## Attention Service Manager/Parts Department

**Subject:** Continuous Product Improvement - Introduction of More Robust Rocker Switch Assembly

**ECO#:** A-6488

**Figure 3:**  
Degraded contacts in  
old switches 56265097  
and 56265107

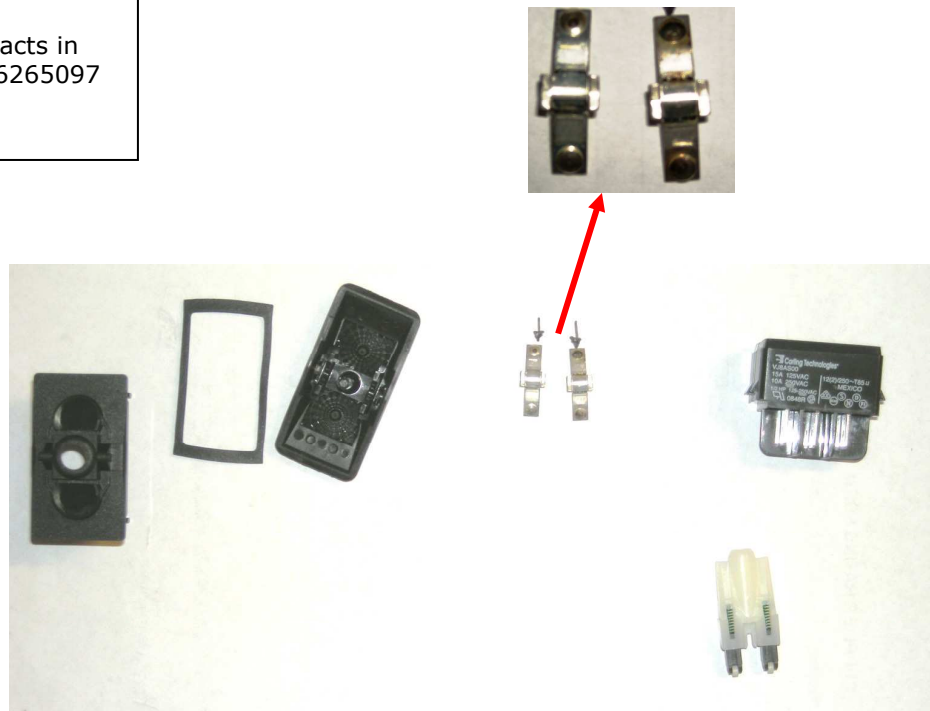
**Issue:** In some applications, premature rocker switch failure is causing the internal switch contacts to degrade quickly (Figure 3).

**Cause:** This premature failure is caused by the high in-rush current characteristics required for initial vacuum motor startup.

Effective March 31<sup>st</sup>, 2011 and beginning with serial number 4000015734, the switches that had been used previously were changed to a new and improved switch:

New switch 56381823 replaced switch 56265097

New switch 56381824 replaced switch 56265107
